IEEE 802.11
Wireless Access Method and Physical Specification

Title: **FH PHY Proposed Revisions to Section 10**

Date: March 28, 1995

Abstract: This paper presents the changes to section 10 in the Draft Standard P802.11/D1 as a result of the Response to Draft D1 Letter Ballot processed at the March 1995 Meeting as shown in the companion document P802.11-95/77

Figure 10-17: Transmit Spectrum Mask

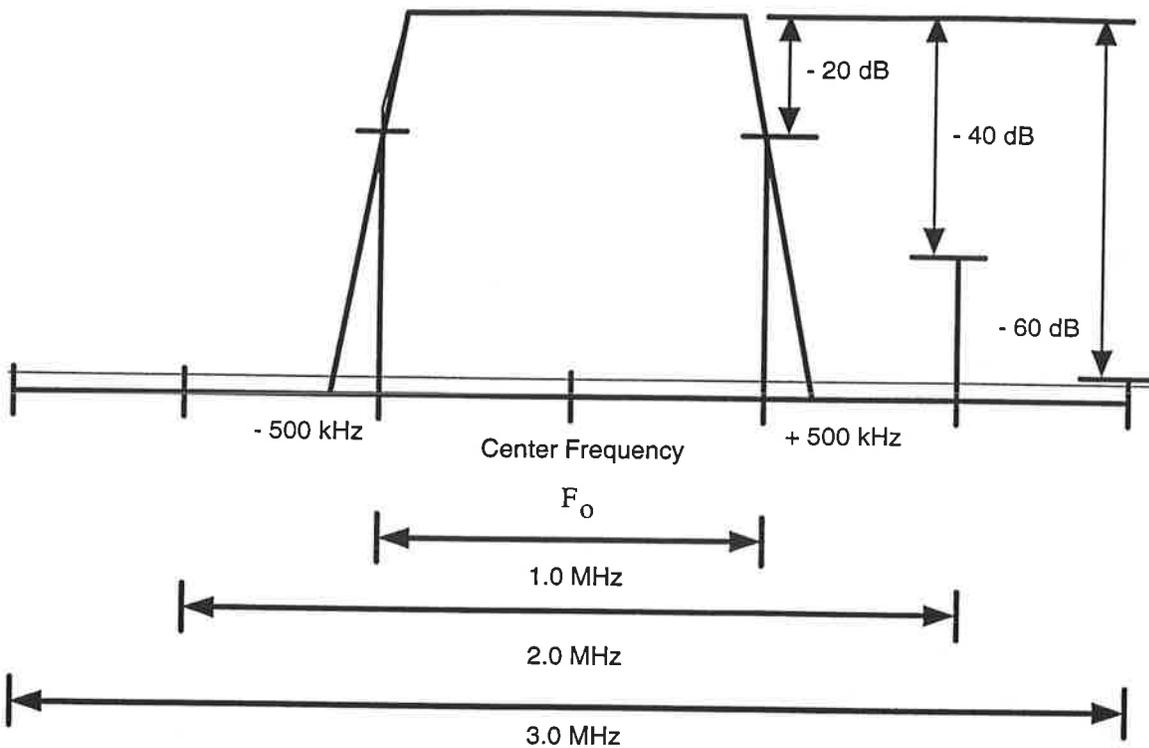
Within the frequency band of 2.4 GHz to 2.4835 GHz, ~~two~~ three failures are permitted providing they are less than -50dBc.
